UTILITY PLAN

DRAWN BY: **CLL**
 CHECKED BY: **TVB**
 DATE: **2 May 2002**
 PROJECT NO: **4010057**
 SHEET NO: **C4**

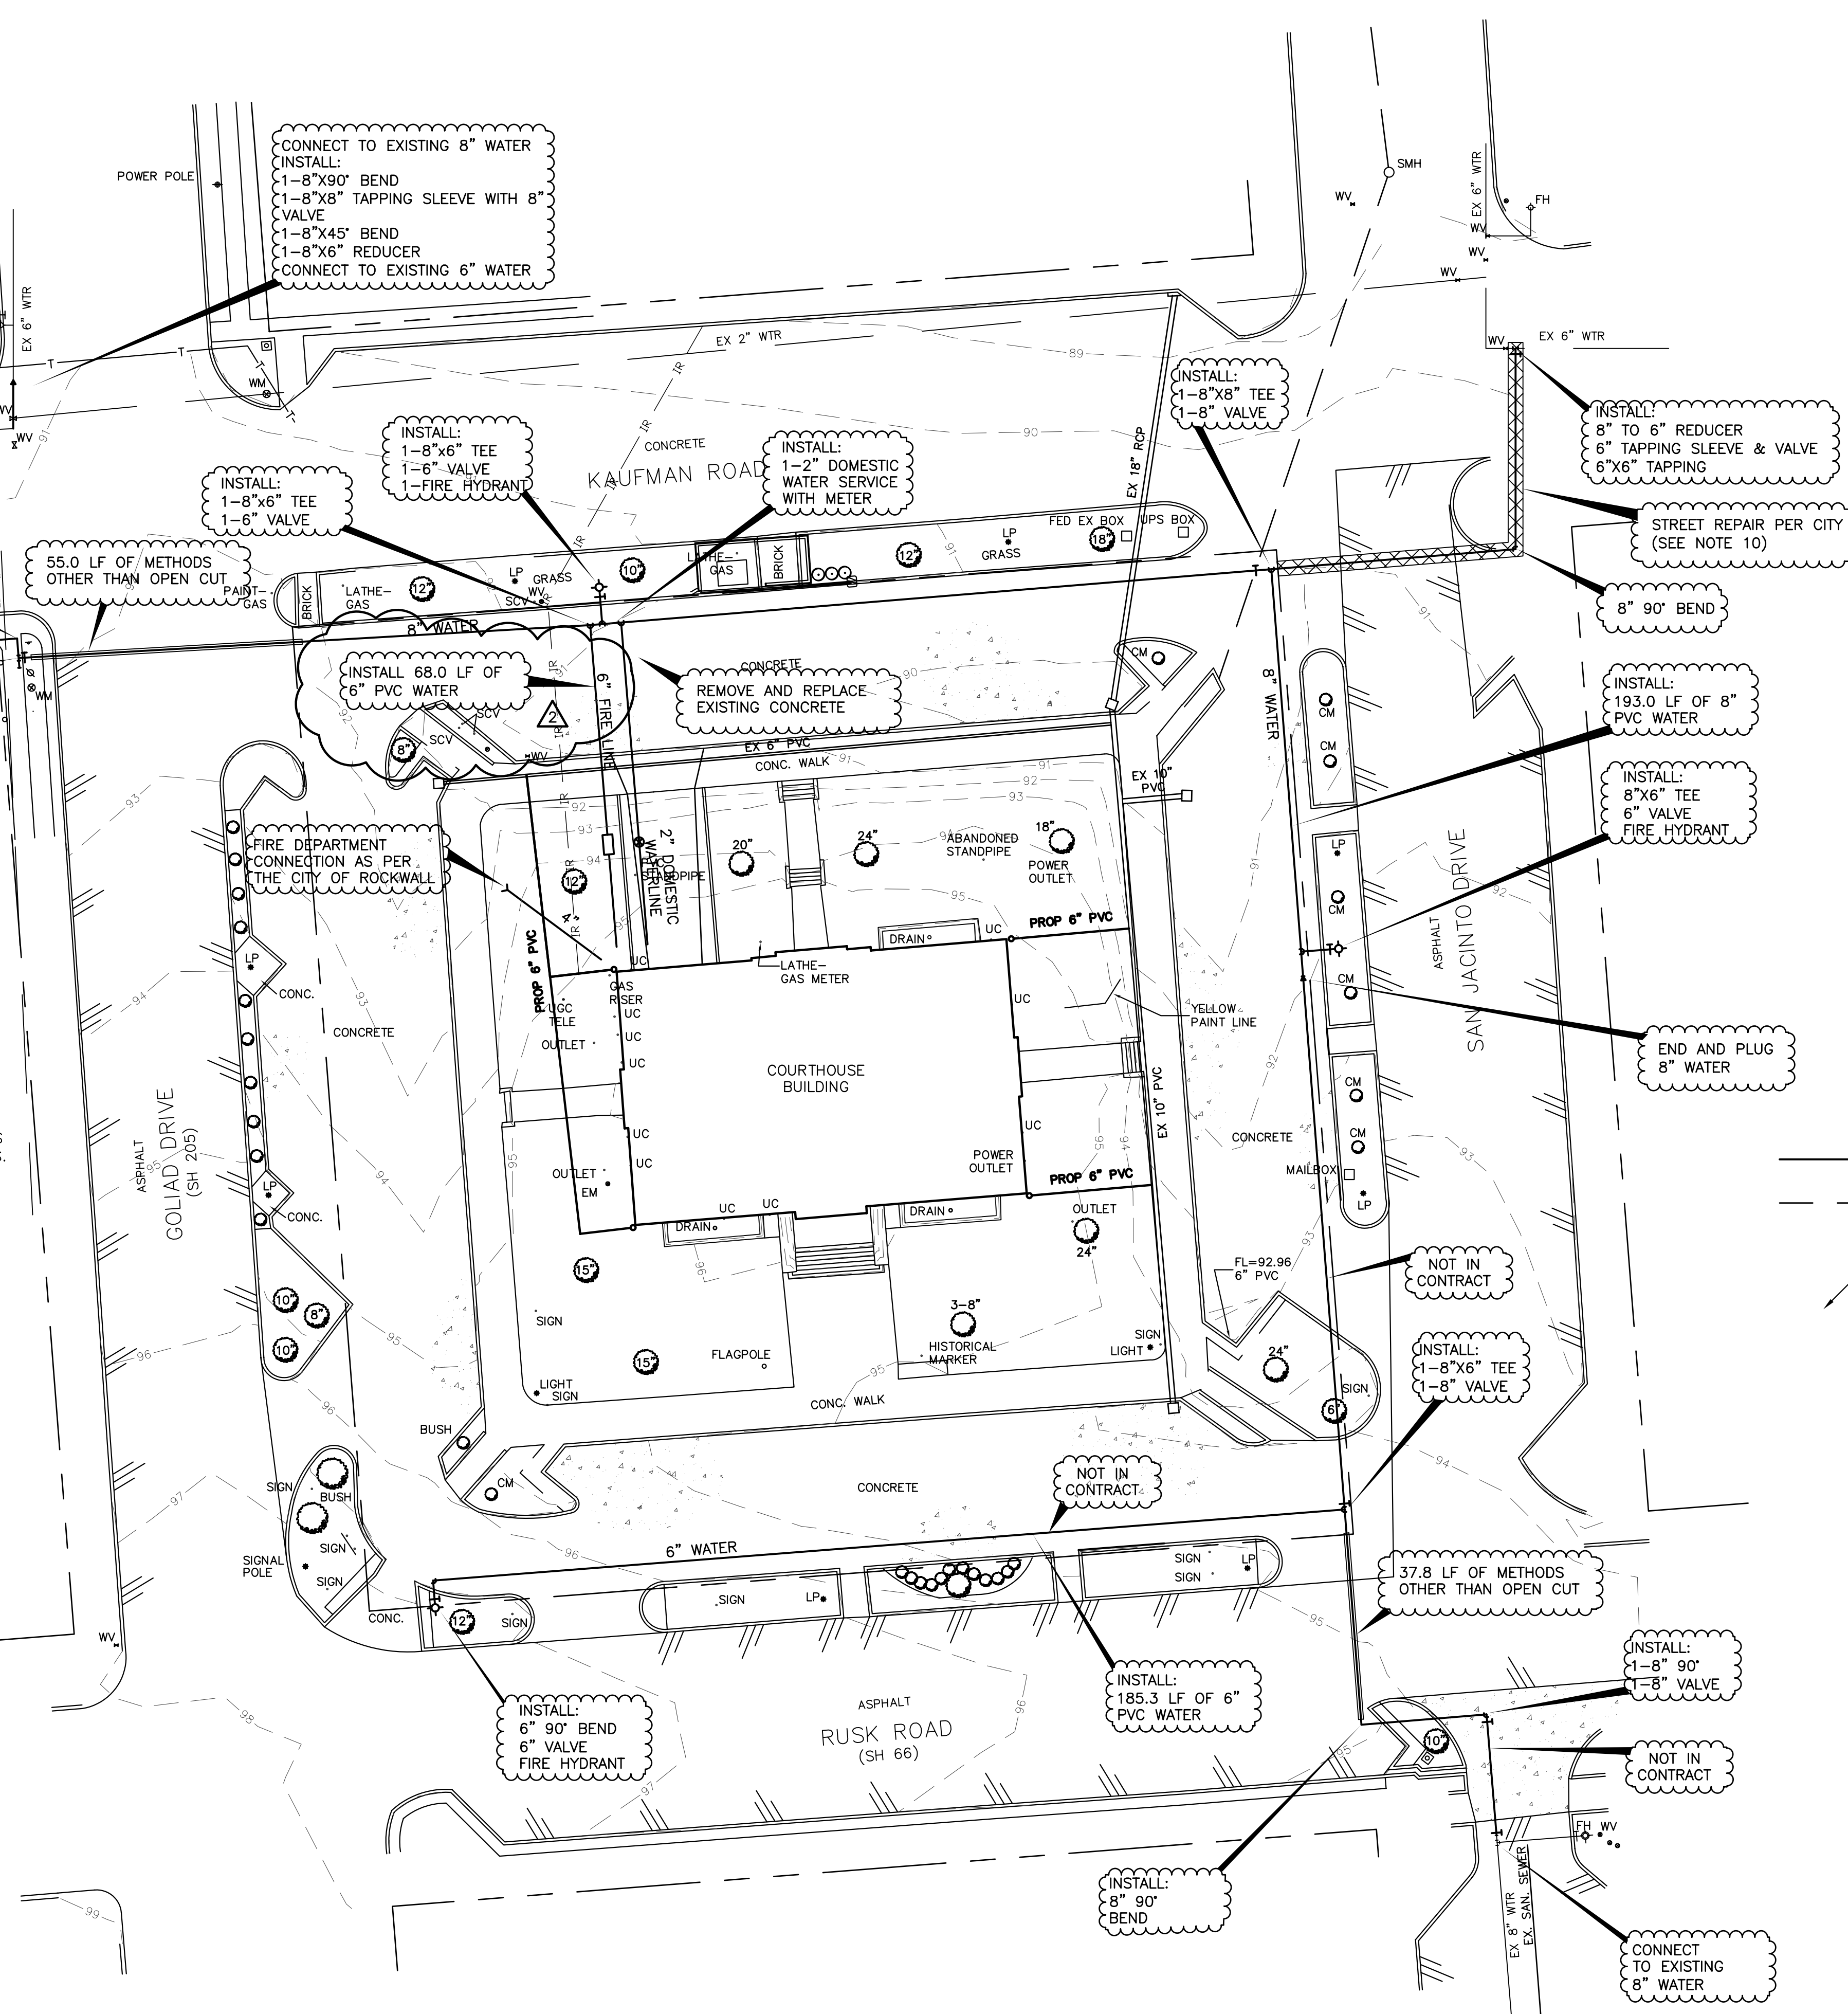
Revised quantity of
 6" PVC Water from
 164.09 LF to 68.0 LF
